Questions & Answers
ITB-UNDP-PETRA-92264-002-2020

Procurement of Works: Construction of Health and School Facilities in Lombok

LOT 1 – Medical Drawing Ref # ARDC-S-PSKM/LL-18

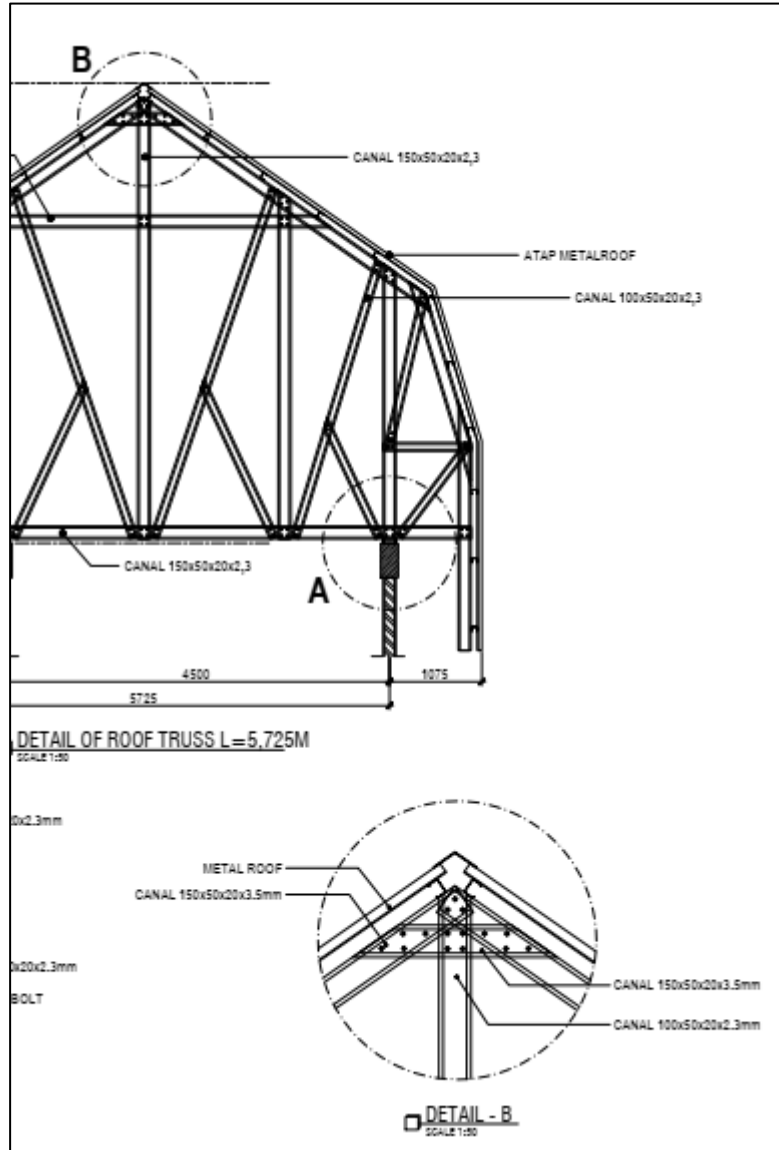
Q: There is question that is not yet fully answered from bidders, regarding the structure of light steel roof truss material. In the *Questions and Answer (Q&A) – Part 3*, it was stated that the required type was G550 mild steel, but the answer did not explain the dimensions to be used. As it is known that options for the type of Zinalum in the market are vary in regard to dimensions, but none could apply to what is indicated in the Drawing. Please clarify on both of the type and dimensions that are going to be used, as it would affect the consideration of unit price and the overall value of both LOT 1 & LOT 2.

Types of Roof Truss are Canal C/ C Truss C150 and C100. Please refer to the drawings for the information on dimensions.

Type Profile Lightweight Steel Frame Profil Canal with dimension

- Roof truss : Canal (Profil C) 100x50x20x3.5 mm
- Wind Bracing : Canal (Profil C) 100x50x20x2.3 mm
- Roof Cover : zincalum sheet t = 0.4 mm with clip-lock system
